4.1 Conclusions	4-1
4.2 Recommended Scope and Budget for Fiscal Year 2014-15	4-2
4.3 Recommendations for Changes to the MZ-1 Plan.....	4-3
Section 5 – Glossary	5-1
Section 6 – References	6-1
Appendix A – Monitoring Data through December 2013	
Appendix B – Comments and Responses

Land Subsidence Committee
 2013 Annual Report

Figure 1-2

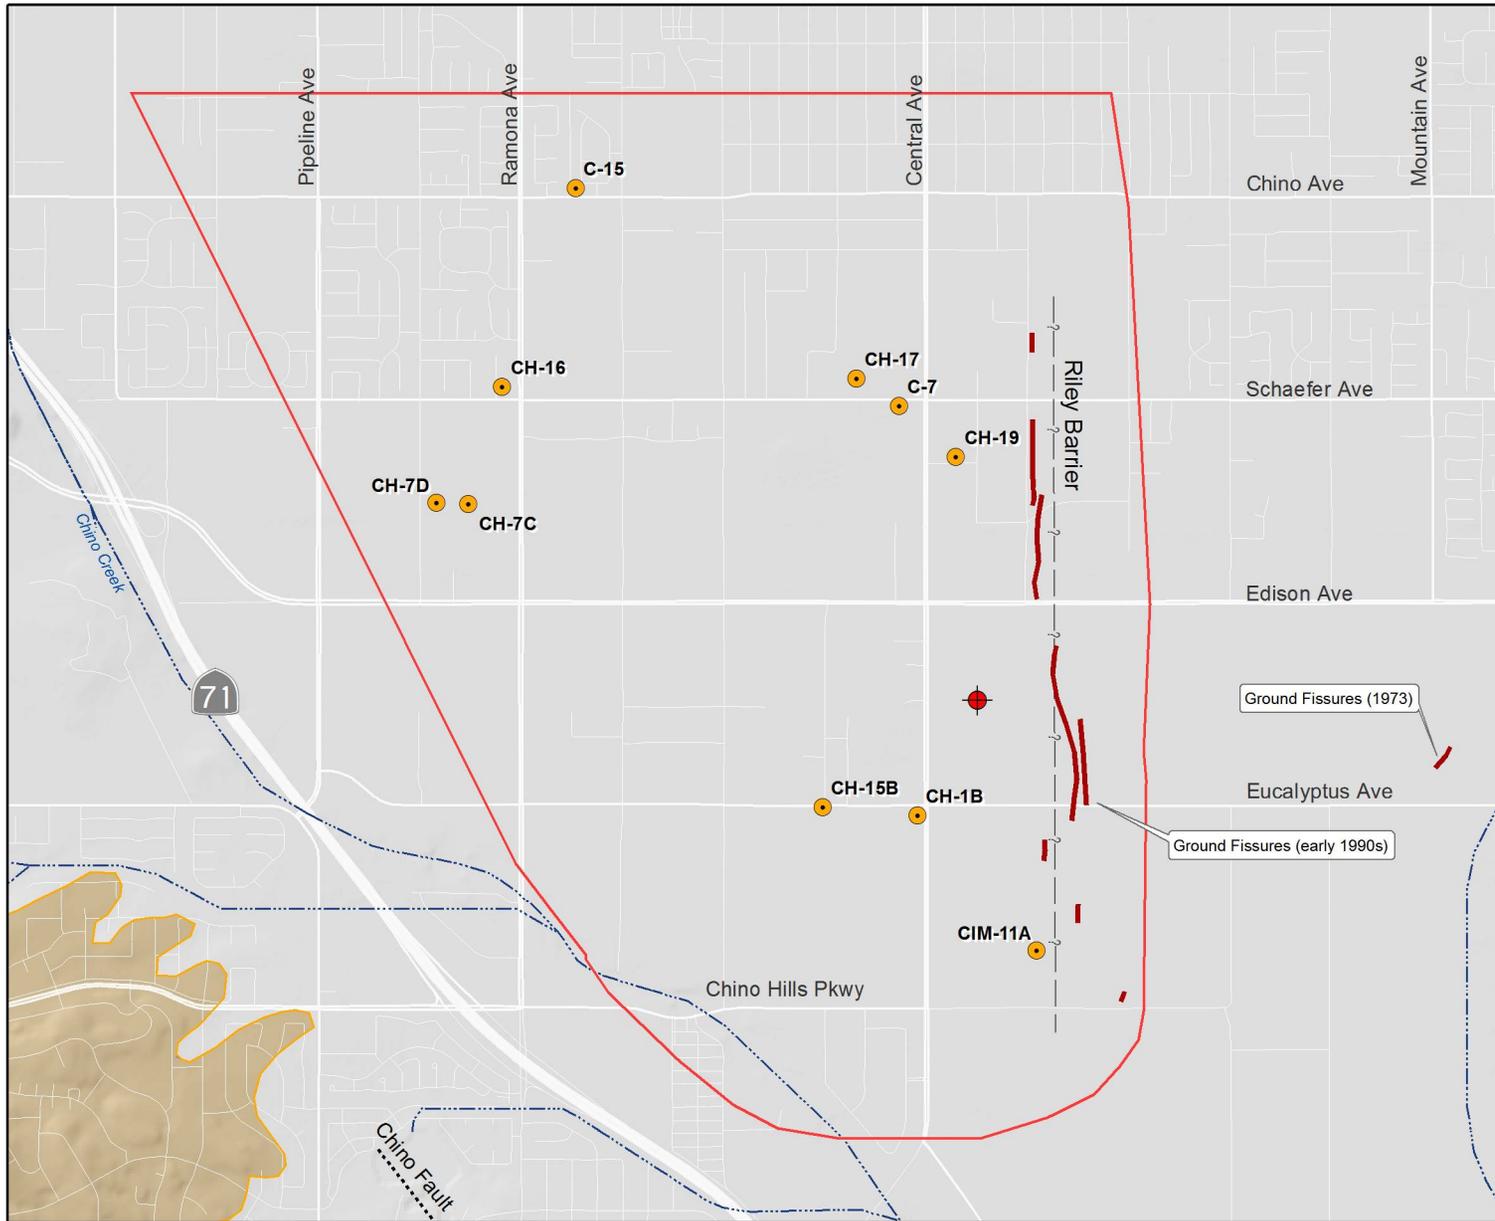
Comment Number	Reference	Comment	Response
1	Figure 1-1	Three wells are not currently active (see figure from MVWD)	This figure was updated to show wells that were active during the period specified in the figure. Text was added to the figure to clarify.
2	Section 4.1	Is this goal too ambitious for now? Shouldn't the first big thing we do is to assess and monitor the Pomona area. Do we have guidance criteria for the other unmanaged areas? If not, why not?	<p>The recommendation in the annual report is to “develop a subsidence management plan for the Pomona Area with the long-term objective to minimize or abate the occurrence of the differential land subsidence” in the area. This is a long-term recommendation.</p> <p>The recommendation for 2014-15 is to begin the process with a scoping effort by the Land Subsidence Committee. This will likely entail multiple meetings over the year to develop scope, schedule, and budget estimates. The scope may need to include a hydrogeologic investigation to (i) definitively characterize the mechanisms driving the observed subsidence and (ii) develop subsidence-management criteria.</p>

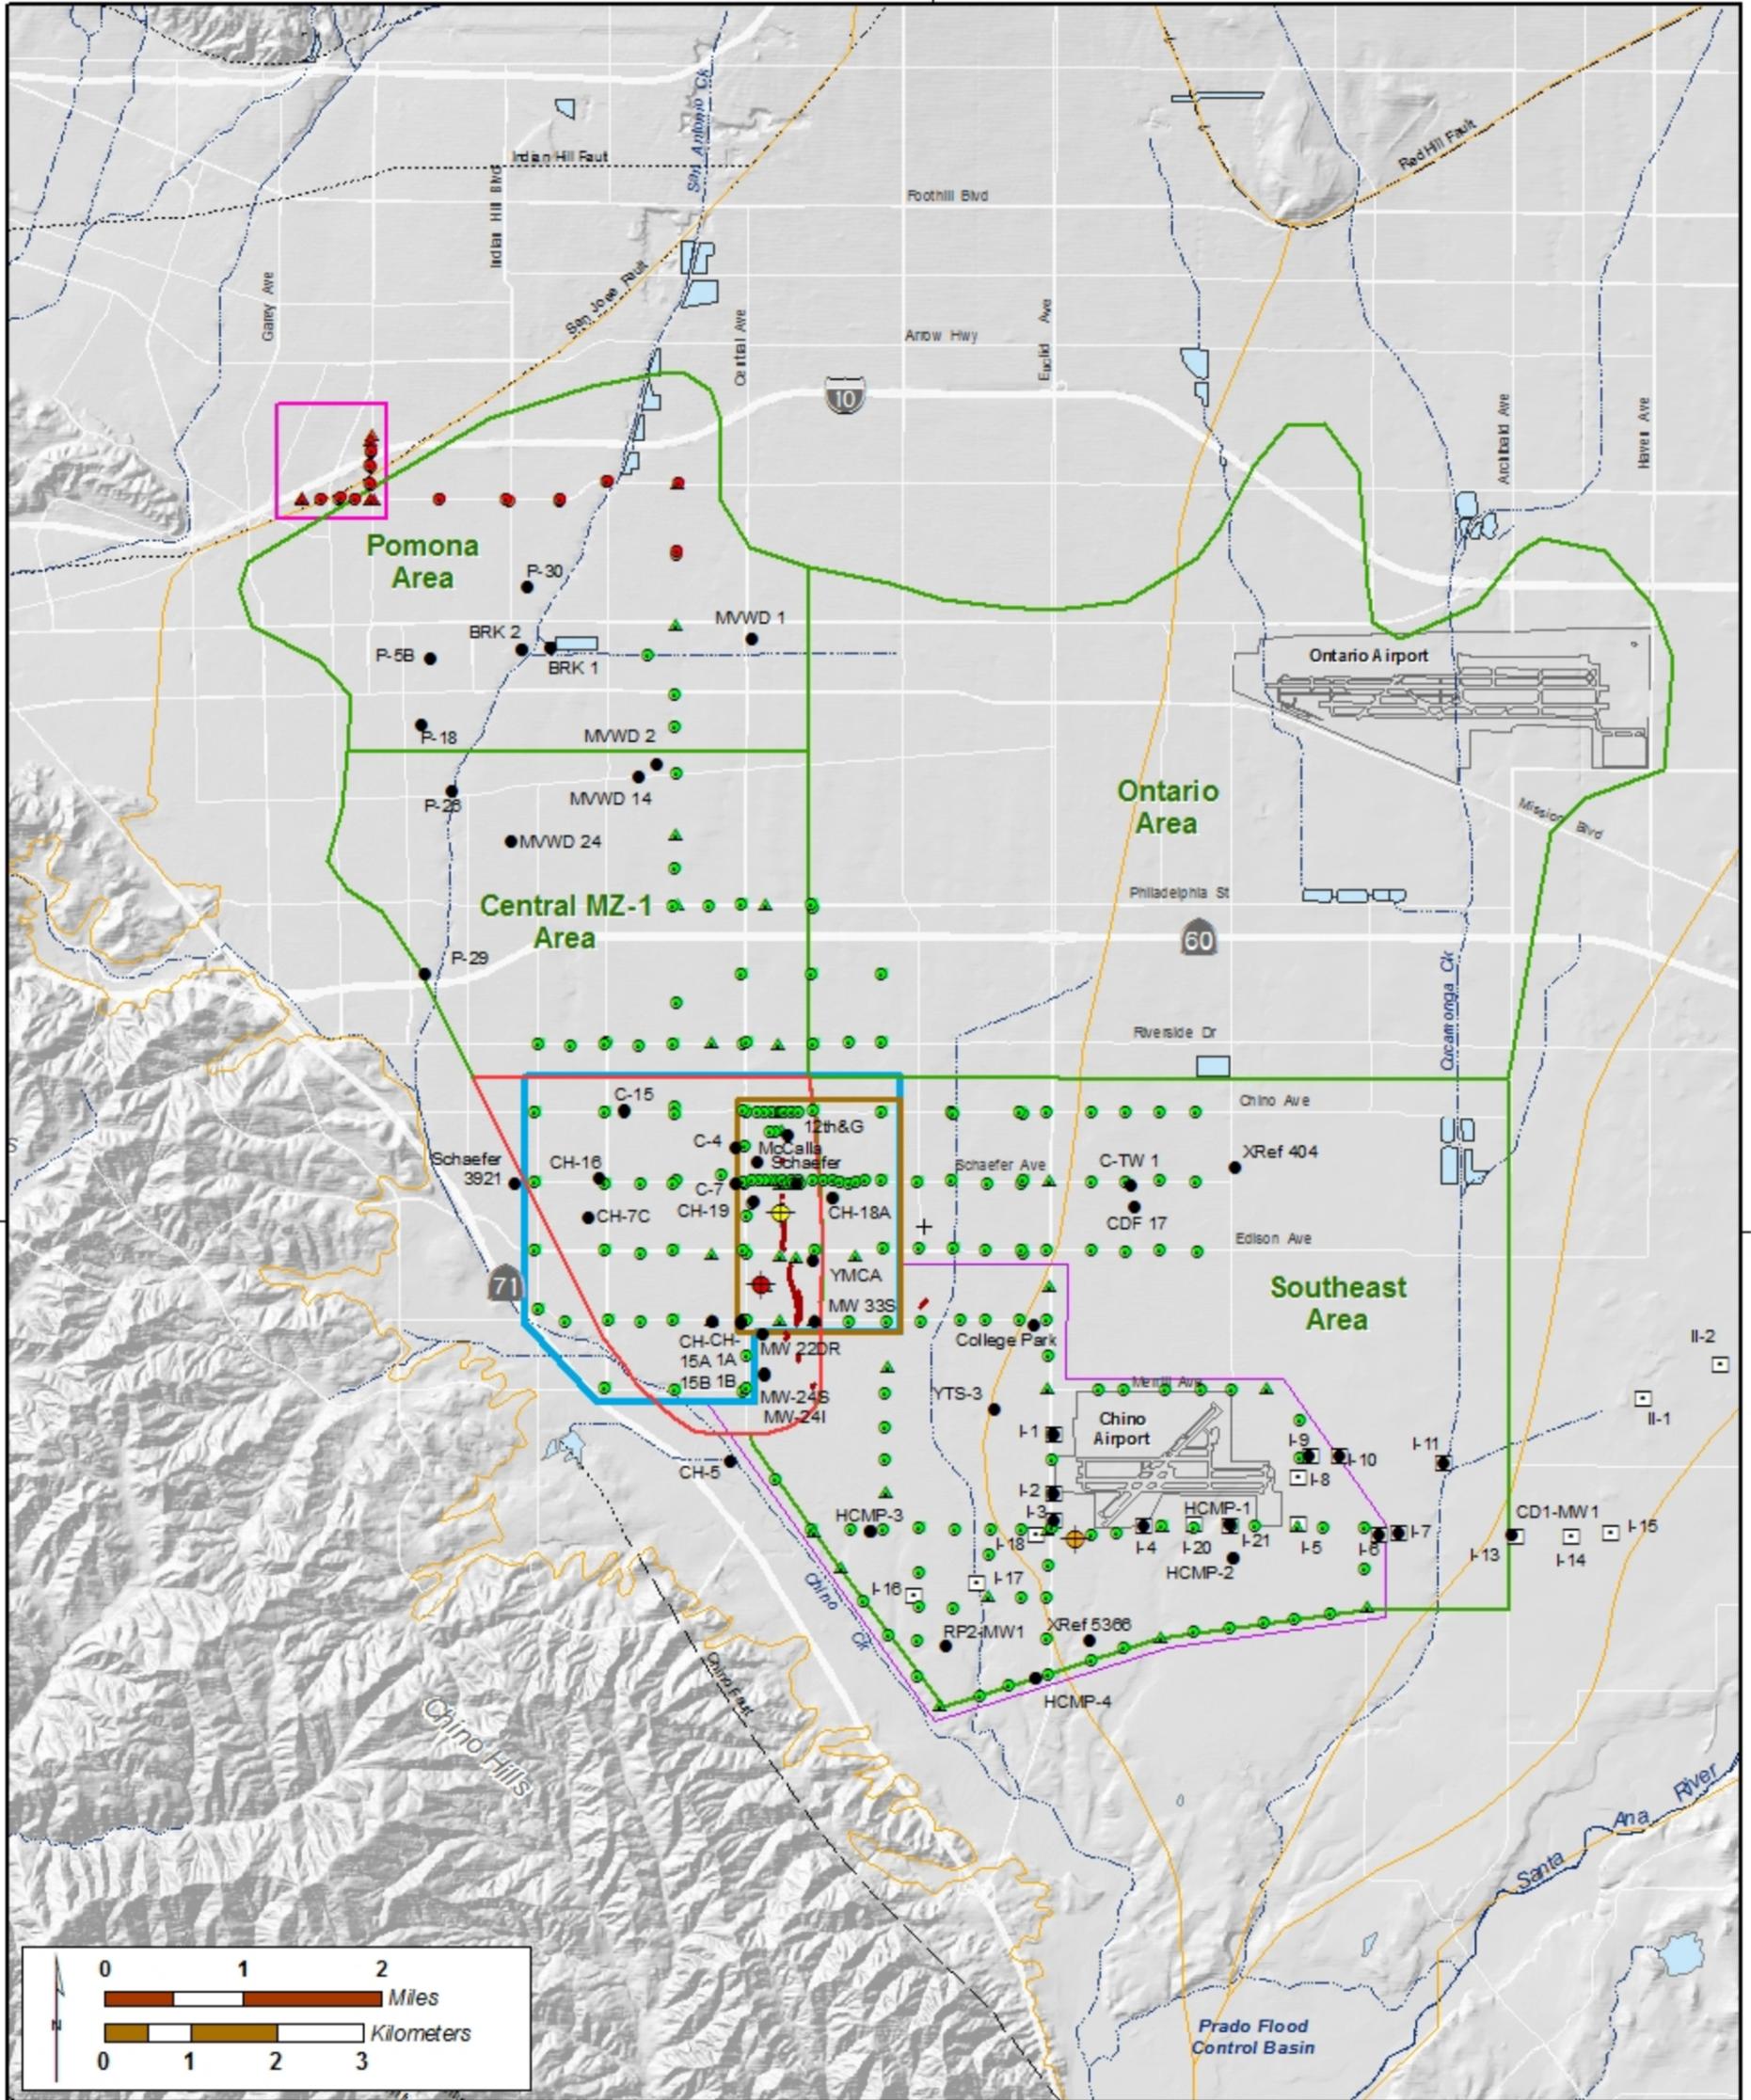
3	Figure 2-1 and 4-1	Transducer instrumented well Xref 5767 is shown on these figures at a location west of Euclid and south of the projected east-west line of Merrill Ave. If this location is accurate, the well would be located on property belonging to the State of California (State). If the well belongs to the State, then it should be identified by its common name.	Comment addressed in the report, on Figures 2-1 and 4-1: The well is owned by the State. Its local name is YTS-3. References to the well have been updated.
4	Page 2-3	First non-enumerated paragraph, first sentence. “CH-17 and CH-15...” Should this be CH-15B?	Comment addressed in report, on page 2-3: The well should be CH-15B. The text was changed to “CH-17 and CH-15B”

Figure 3-1

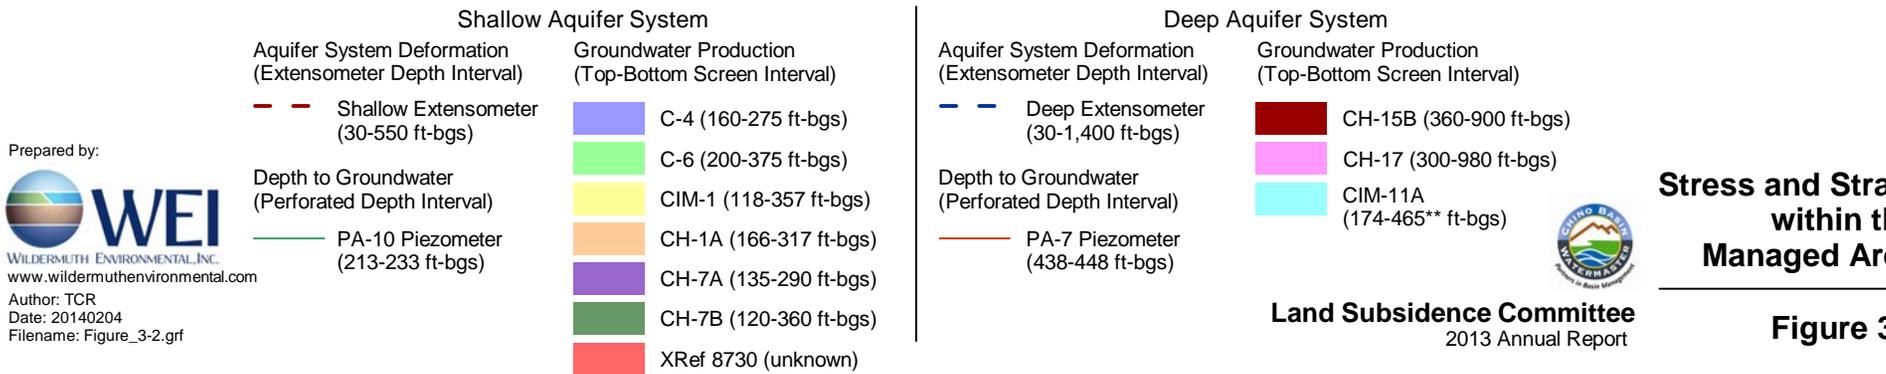
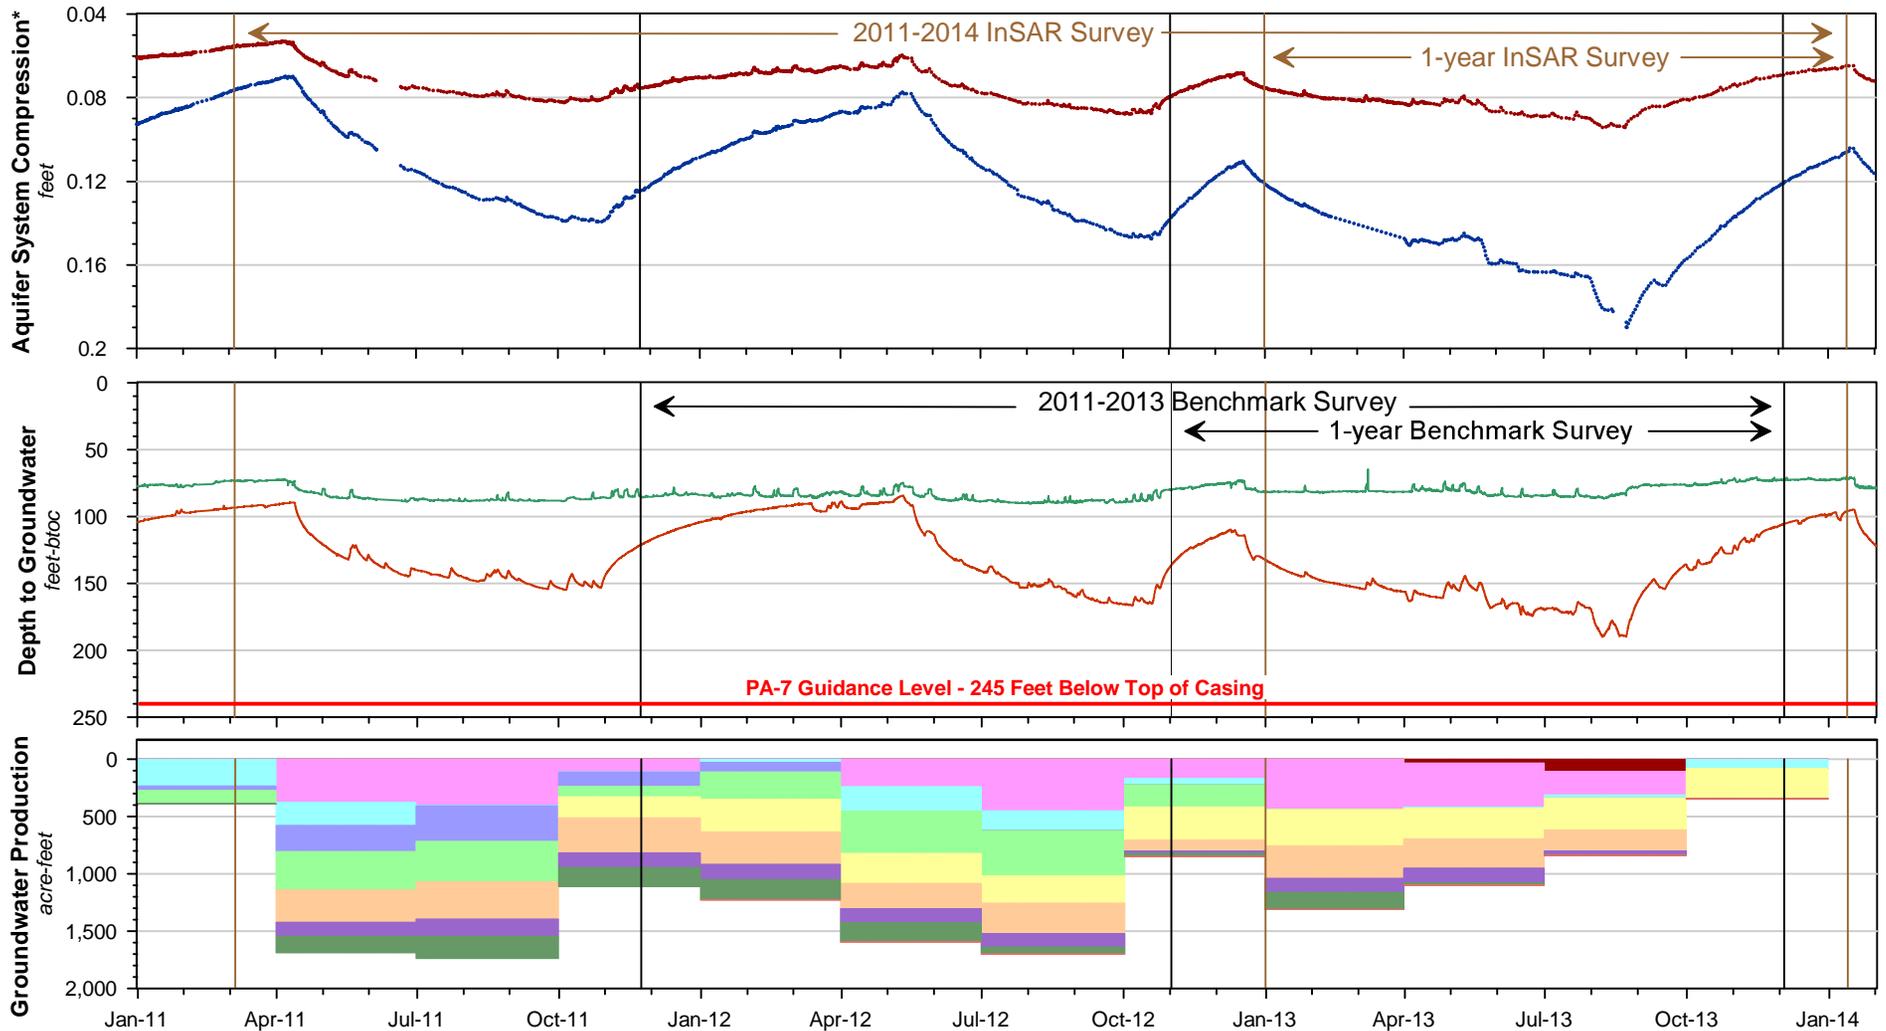
7	Figure 3-1	Last paragraph of narrative, 7 th sentence, "...when piezometric-levels declined below 250 feet below...). Delete first "below" in sentence.	Comment addressed in report, on Figure 3-1: Text was changed to "piezometric-levels declined below a depth of 250 feet below the reference point (ft-brp)"

Vertical Ground Motion across Western Chino Basin

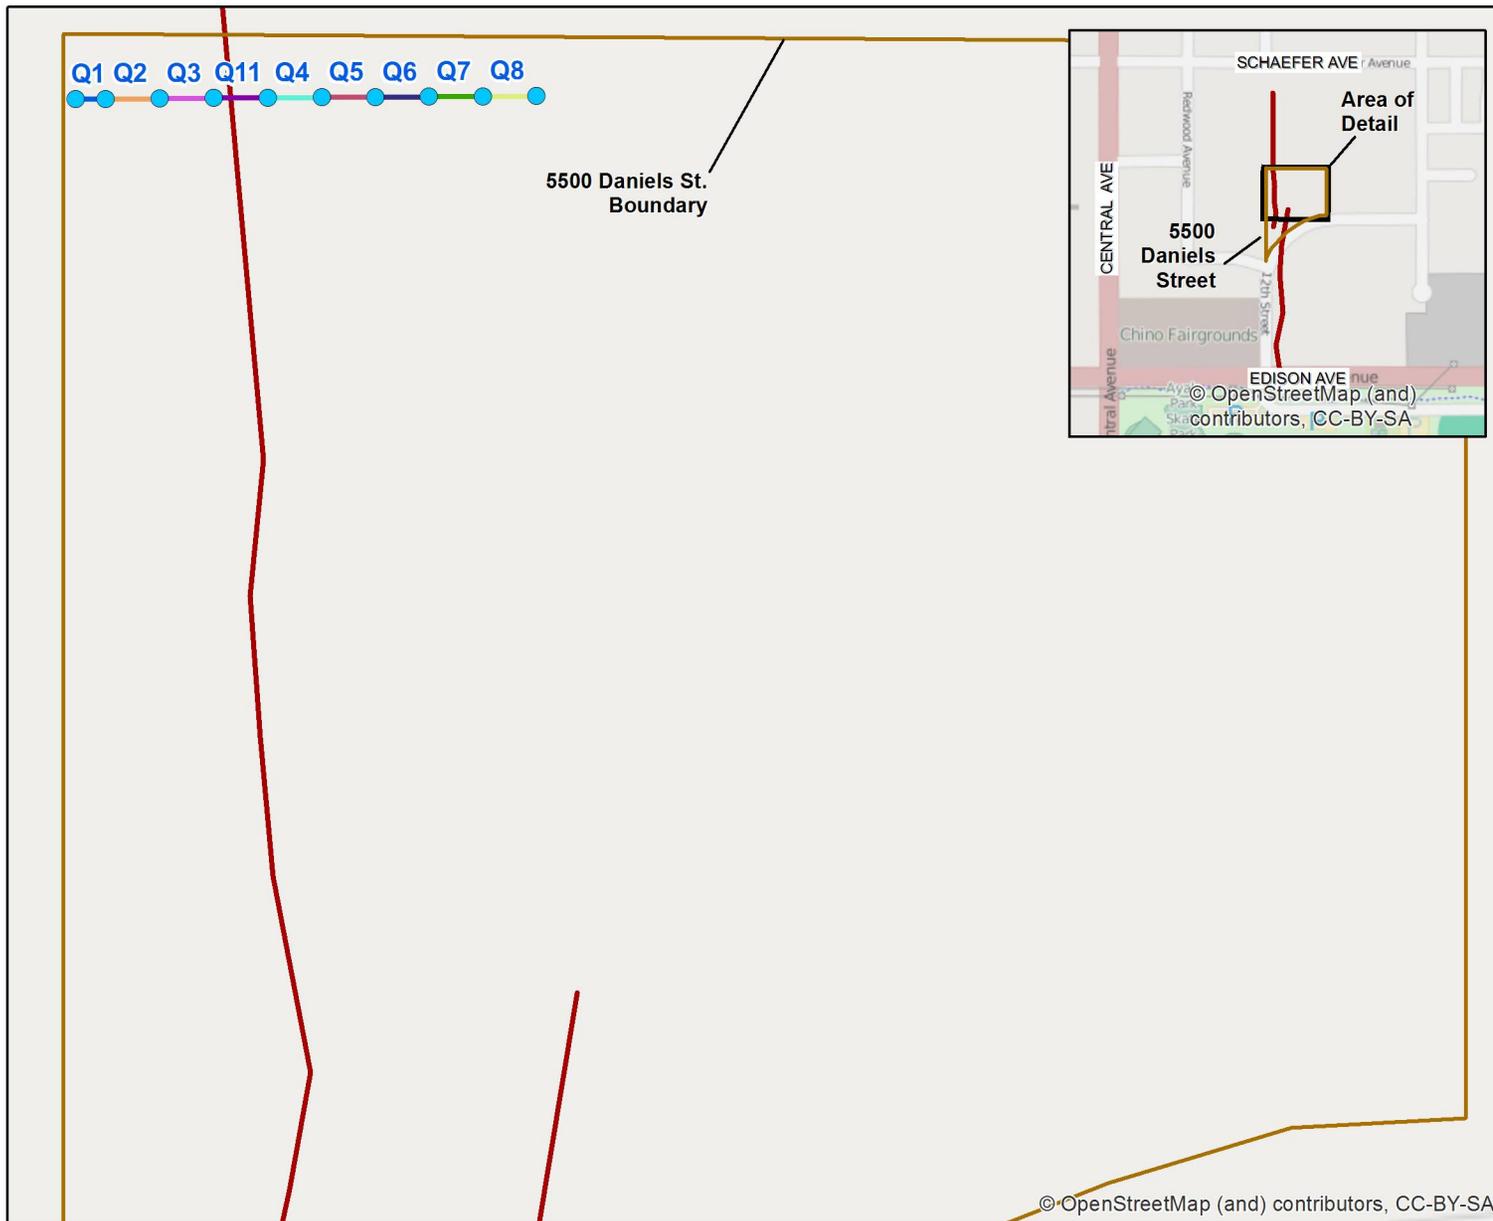
Comment Number	Reference	Comment	Response
8	Figure 3-4 and Figure 3-5	Earthquake epicenters are posted on both maps. The text in the report does not have an explanation as to why these data are relevant to subsidence.	Comment addressed in report, on Page 3-2: "Epicenters of earthquakes that occurred from 2011 to 2014 are included on Figure 3-4 and 3-5. The data show that the vertical ground motion shown on the maps is not associated with earthquake events."
